CITY PLAN COMMISSION STAFF REPORT

Cookingham Development – Expansion

CD-CPC-2025-00024
Rezoning without Plan
CD-CPC-2025-00025
Area Plan Amendment
CD-CPC-2025-00026
Development Plan – Non-Residential

Case Number: CD-CPC-2025-00026

Tree Removal & Tree Preservation Plan

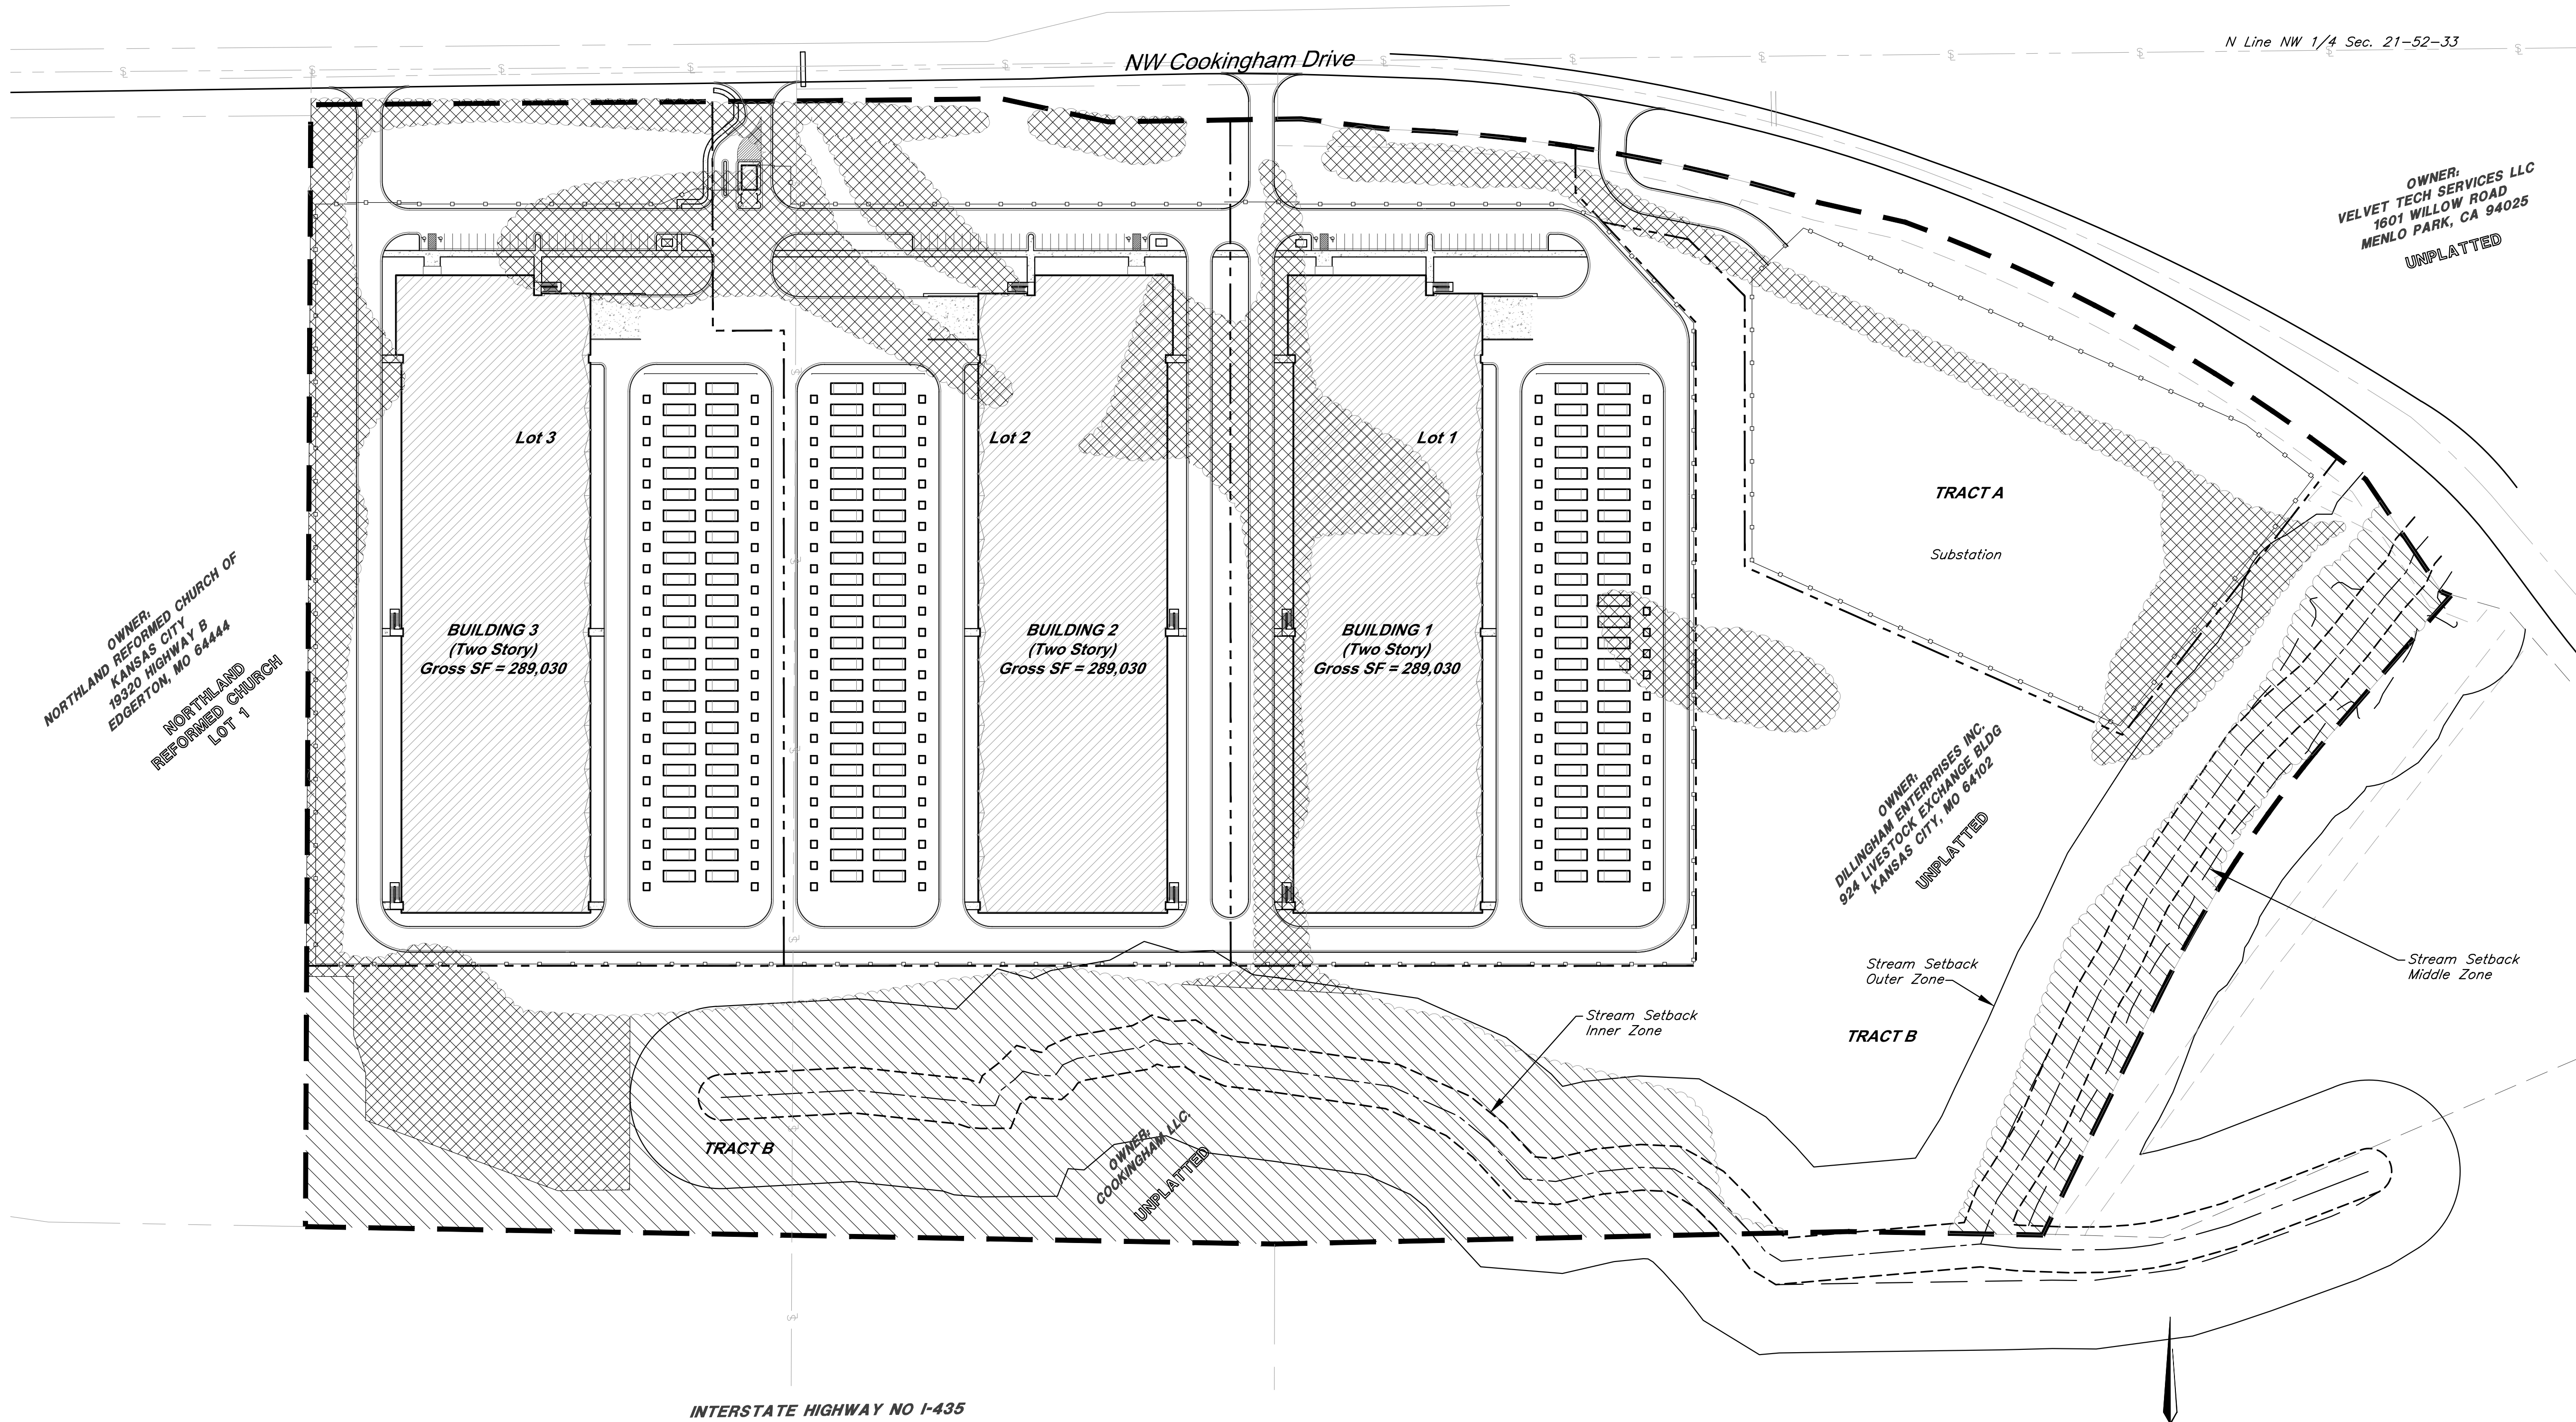
The applicant provided a tree preservation and removal plan. The applicant is proposing to remove over 9 acres of trees for the speculative development. No mitigation is required due to the existing stream buffer.
